Answers to the reviewers comments concerning the manuscript “Validation of satellite-based noontime UVI with NDACC ground-based instruments: influence of topography, environment and satellite overpass time”, by Brogniez et al.

Anonymous Referee #1

Anonymous Referee #2

Anonymous Referee #3

Figure 5.

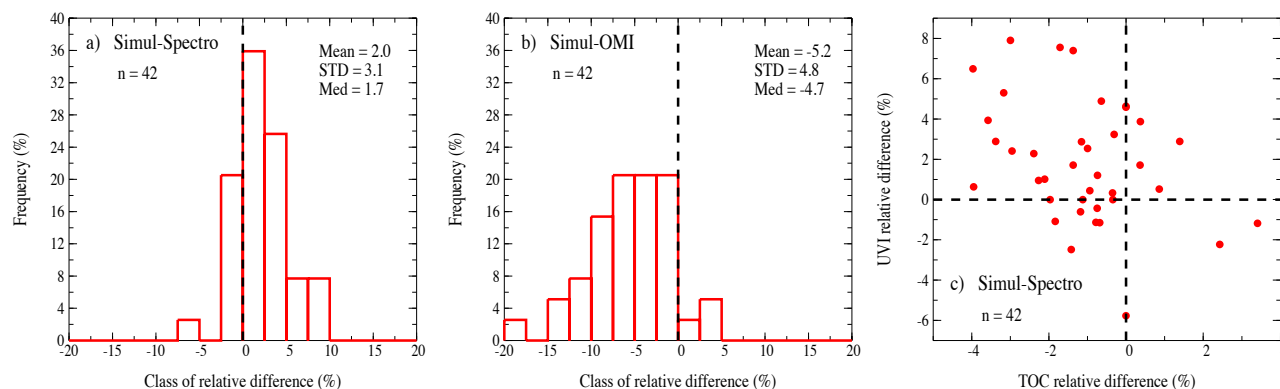
In CS cases after the OMI correction there is still a bias. Where this bias come from ? One factor can be an OMI underestimation of Total column Ozone (TOC). Has this been checked with GB measurements?

Even if the TOC is more or less correct, what is the UVI calculated by a simple radiative transfer model using only OMI derived related inputs (solar zenith angle, TOC, AOD, albedo)?

We have compared the TOC derived from OMI (OMTO3) with the one derived from the spectroradiometer's spectra for several cloudless sky cases at the three sites. It appears that OMTO3 is often smaller than TOC from the GB instruments. (See below the text we have added).

We agree that such a study could help to understand the results, so a modelling study has been added. We have preferred to use ancillary data from various sources because, apart from the differences that would exist between the radiative transfer models, there might be issues with the input parameters.

In the modelling study for VDA, after the description of the radiative transfer computations (**lines 290-298**), we have added the following text (**lines 299-325**) :

“We have compared the simulated UVI to both OMI and GB UVI for several cloud-free cases. The histograms of the per cent relative difference between the computed UVI and the measured one are reported in Fig. 5a for GB UVI and 5b for OMI. GB UVI are 1.7 % lower and OMI UVI are 4.7 % higher than the simulated UVI, each value being within GB and OMI measurement uncertainty respectively. Since the TOC is the same for both modelling and OMI, this overestimation of OMI UVI might be mainly related to aerosol parameters and surface albedo, though this parameter value is small. Of course part of the bias might come from differences between the two RT models used and also between the other input parameters. Kazadzis et al. (2009b) concluded also to an overestimation due to aerosol variability (in time and space). We of course have to keep in mind that modelling computations are affected by uncertainties.

For this previous modelling we have chosen OMTO3 but other TOC data could be used, such as the TOC derived from the GB spectra following the method described in Houët and Brogniez (2004) relying on a differential absorption technique (Stamnes et al., 1988). The accuracy of this product is about 3 %. We find that this TOC is often larger than OMTO3, which is in agreement with Antón and Loyola (2011) findings for cloud-free conditions (OMTO3 smaller than GB-TOC by 2-3 % on average). Figure 5c shows the UVI relative difference between the computed and the GB UVI versus the TOC relative difference. The computed UVI is often larger than the GB UVI for a negative TOC relative difference, which could explain the 1.7 % bias. Note that the denominator of the relative differences (UVI or TOC) is the mean, contrarily to the SB – GB comparisons because, in this study, neither data is considered as a reference.

Another TOC product from OMI (OMDOAO3) exists, which is sometimes quite different from OMTO3 (either larger or smaller) leading to a different modelled UVI and thus to a quite different relative

difference. For example a relative difference between GB UVI (4.8) and UVI modelled using OMTO3 (290 DU) equal to 7.6 % has become equal to 4.8 % while using OMDOAO3 (297 DU).

TOC from GOME-2 is also sometimes different from OMTO3, and often smaller than spectroradiometer-TOC.

Underestimation of OMTO3 and of GOME-2 TOC for cloud-free and cloudy cases, as is found also by Antón and Loyola (2011), can explain part of the observed biases between SB and GB UVI. Aerosol climatology from Kinne et al. (2007, 2013) might also contribute to the biases. Indeed, these aerosol climatologies rely on AERONET data that show an interannual variability, and the gridding is $1^\circ \times 1^\circ$ in latitude-longitude. Cloud cover variability within the satellite pixel (Kazadzis et al., 2009b) is expected to contribute to the biases as well as the surface albedo climatology from Tanskanen (2004).”
